# MY2 (2022) MONITORING REPORT

## SHAW'S RUN MITIGATION SITE

## Response to Monitoring Year 2 (2022) DMS Comments

Shaw's Run Mitigation Site

Figure 1. Current Conditions Plan View

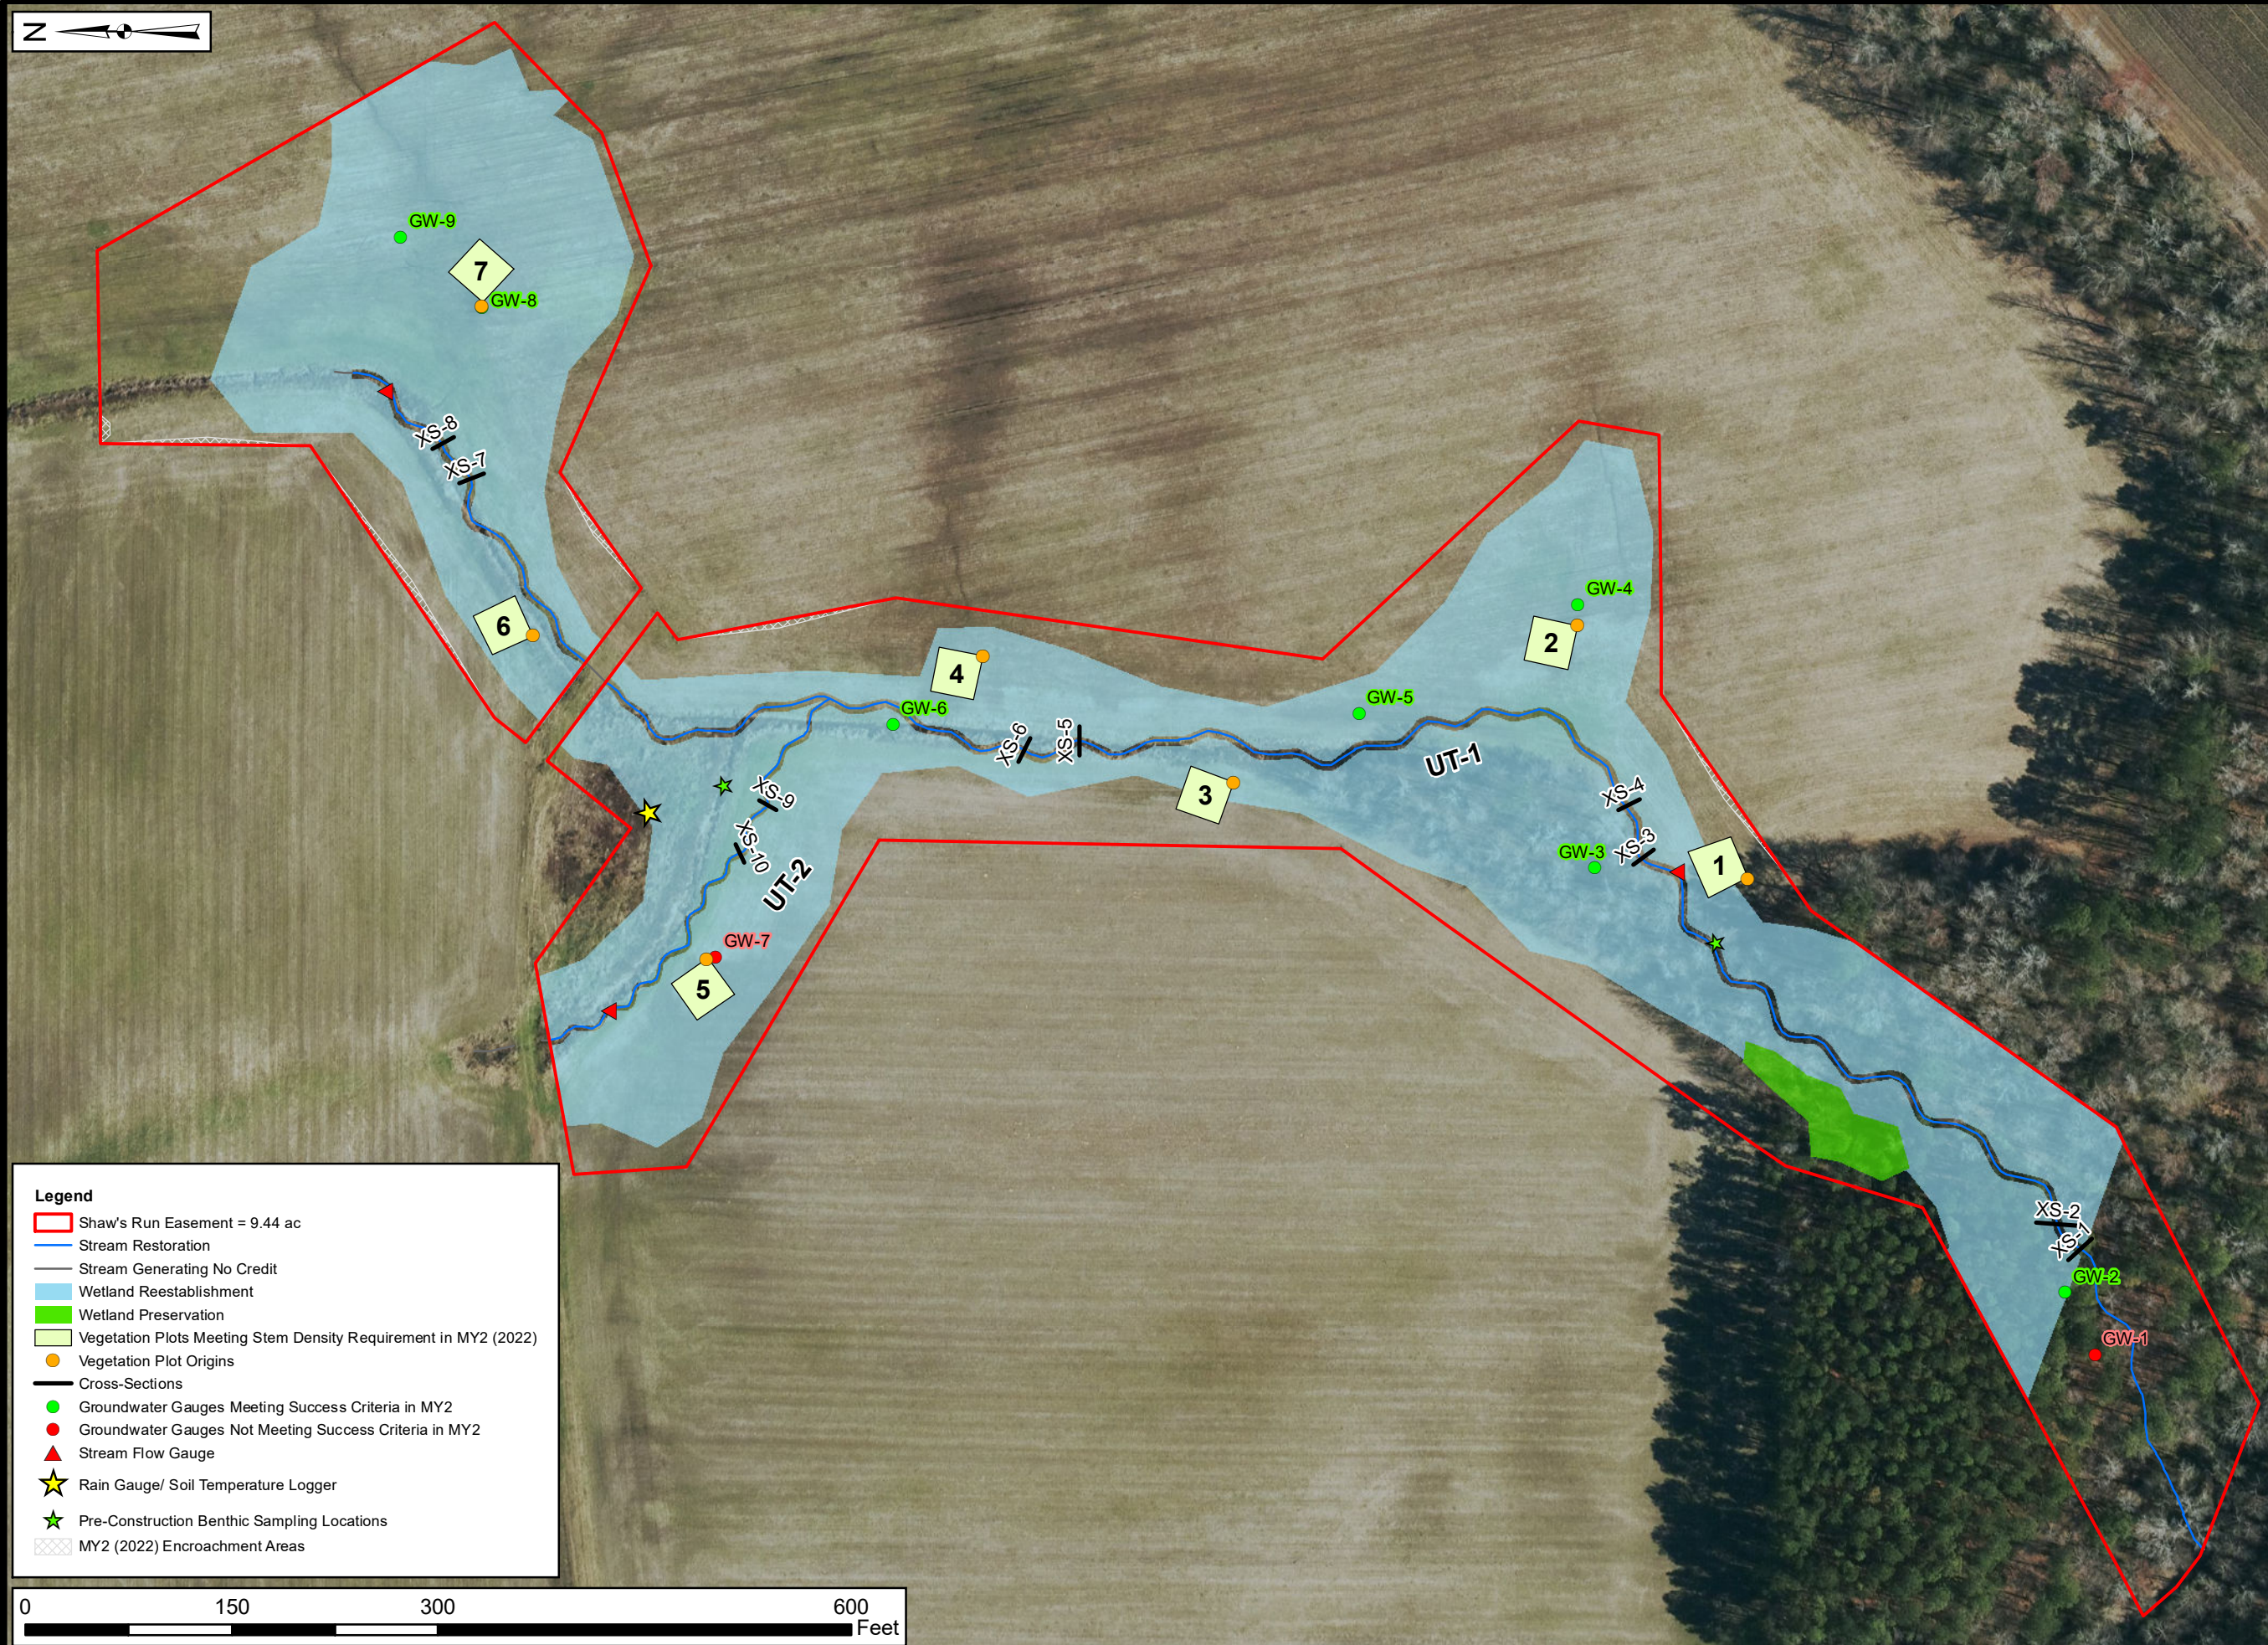
1. Site Maintenance Report: Invasive species have been treated this year but is not mentioned in the report. Please discuss the work that's been completed in the narrative of section 2.1 and add to CCPV/Table 5 if greater than 0.1 acres.

1. As discussed in the field there are multiple farming encroachments. Within the report, please detail the remedial actions for the encroachments (timeline, marking, planting, landowner coordination, etc.) and include all encroachment areas on the CCPV/Table 5 and as a shapefile. Photo documentation of completed work must be included in the MY3 report.

Response: A narrative regarding the small farming encroachments around the Site (0.057 acres total) was added to the Monitoring Summary portion of the report which includes corrective actions. The encroachment areas were also added to the CCPV and Table 5.

# Shaws Run Groundwater Gauge 7 Year 2 (2022 Data)

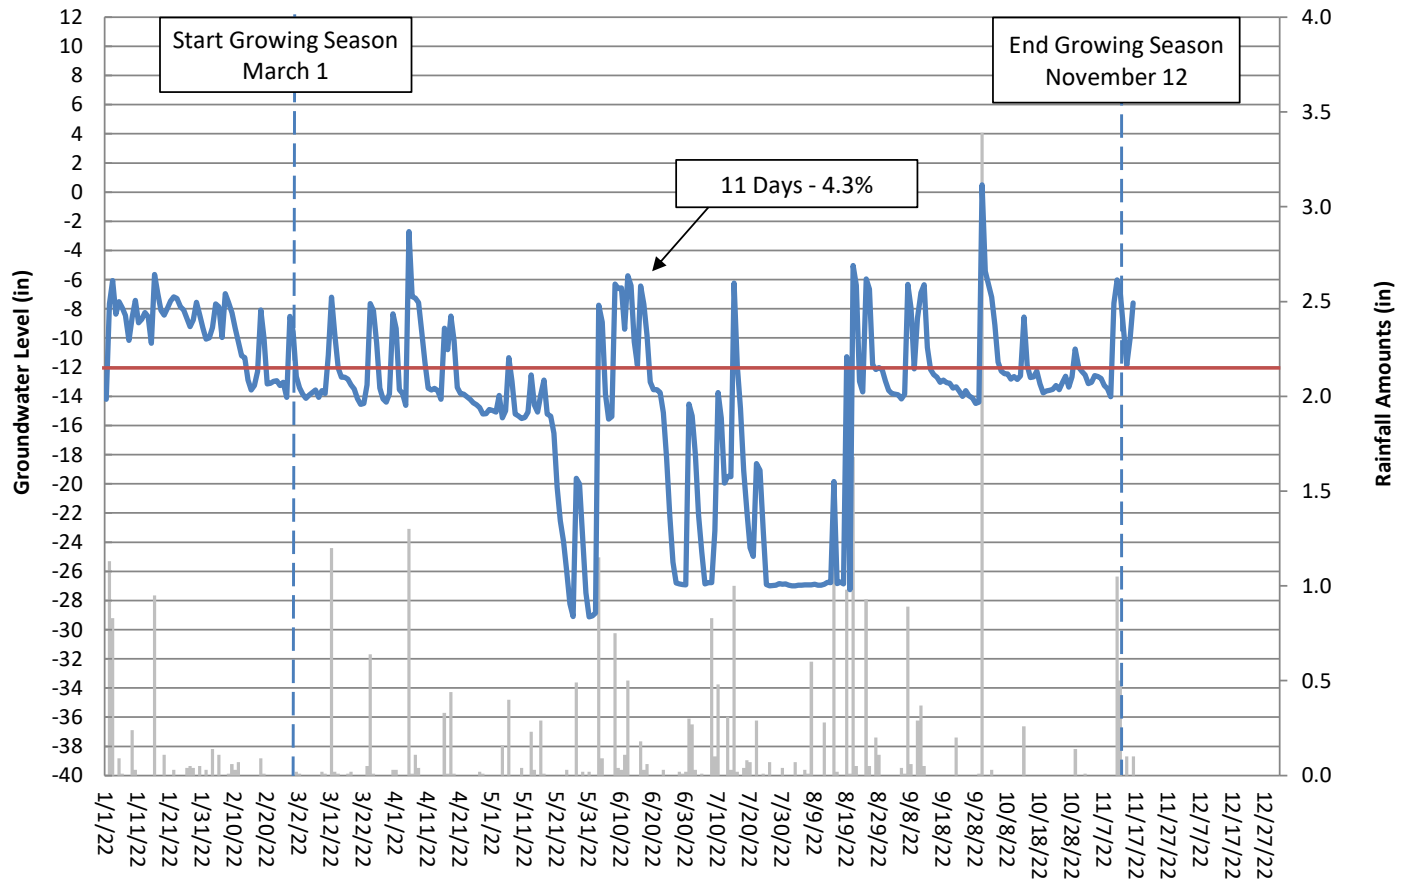
2. 2.1 Monitoring Stream Summary: In the wetland summary section there's a reference to abnormal rainfall conditions as a contributing factor for the failure of gauge 7. Please discuss the abnormal conditions and provide supplemental rainfall/drought data if necessary.

Response: additional drought related data was added to the report.
